## RE: Foundation Modification for Lot # 112 Pergola Park – 3219 SW Pergola Park Dr Lee's Summit, MO 64081 – Permit # 2021-0529

A subgrade inspection was performed by Residential Engineering Services, LLC (R.E.S.) at the above referenced property. The purpose of this inspection was to determine structural adequacy of the existing subgrade soil at proposed footing elevations for construction of concrete foundation.

A3.1

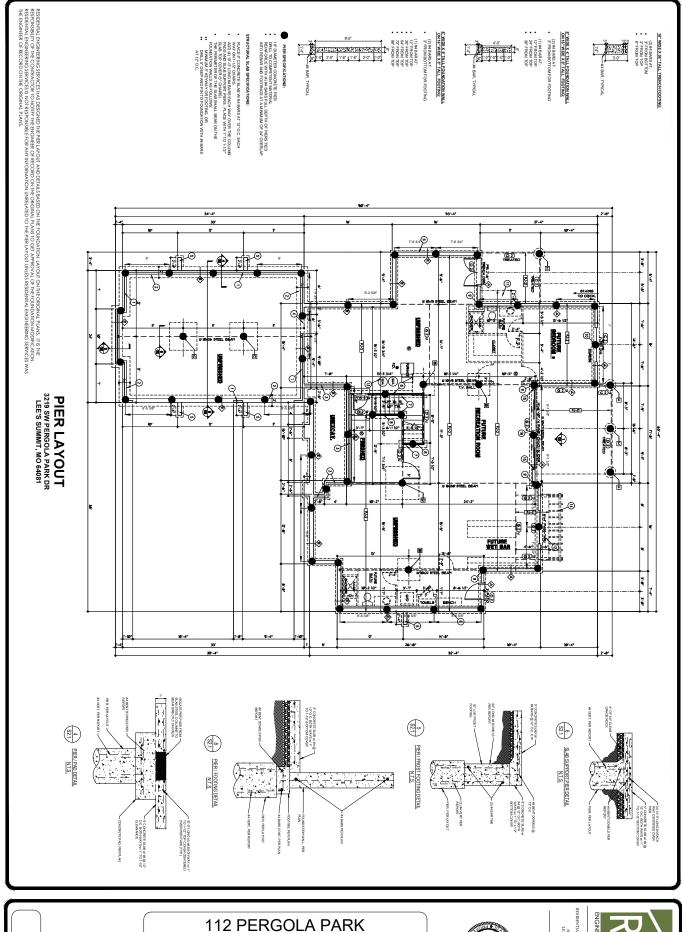
RES has determined that the subgrade material at proposed footing elevations does not have sufficient bearing capacity to properly support foundations for the structure specified in the approved permit plans. RES recommends that the following modifications be made to the foundation plan:

- Drill 18" diameter concrete piers per the attached layout.
- Piers shall be drilled to competent original limestone, sandstone, or shale.
- The piers shall be reinforced with (4) #4 bars for the depth of the pier.
- Lapping shall be no less than 24".
- (4) #4 bars shall extend a minimum of 24" into the footings.
- All piers shall be inspected by our firm prior to the placement of concrete.

Upon approval and completion of the piers, the foundation footings, walls, and slabs shall be placed over the piers. If the city approved plans do not exceed the following minimum specifications, then, as needed, the foundation shall be improved per the following:

- 3000 psi concrete, Grade 60 reinforcing steel, Lap splices min. 24"
- The footing shall be a minimum of 16"x8" with (2) #4 bars continuous.
- The wall shall be a minimum of 8" thick with #4 bars at 24" O.C. each way.
- The walkout frost trench shall be a minimum of 12" wide by 36" deep with (2) #4 bars continuous T&B.
- Grade beams/thickened slabs shall be a minimum of 16" wide by 12" deep with (3) #4 bars continuous T&B.
- The garage and basement slabs shall be structural.
- Place 5" concrete slab w/ #4 bars at 12" O.C. each-way on 1-1/2" chairs.
- Add (4) 10'-0" long #4 bars each-way over the column pads and slab support piers. Place with 1" to 1-1/2" slab top cover (3" chairs). See attached layout and slab details for clarity.

The perimeter of the slab shall bear on the foundation as follows:

• Minimum 3" keyway on footing; OR Drill 5" deep and pin to foundation with #4 bars at 12" on center.
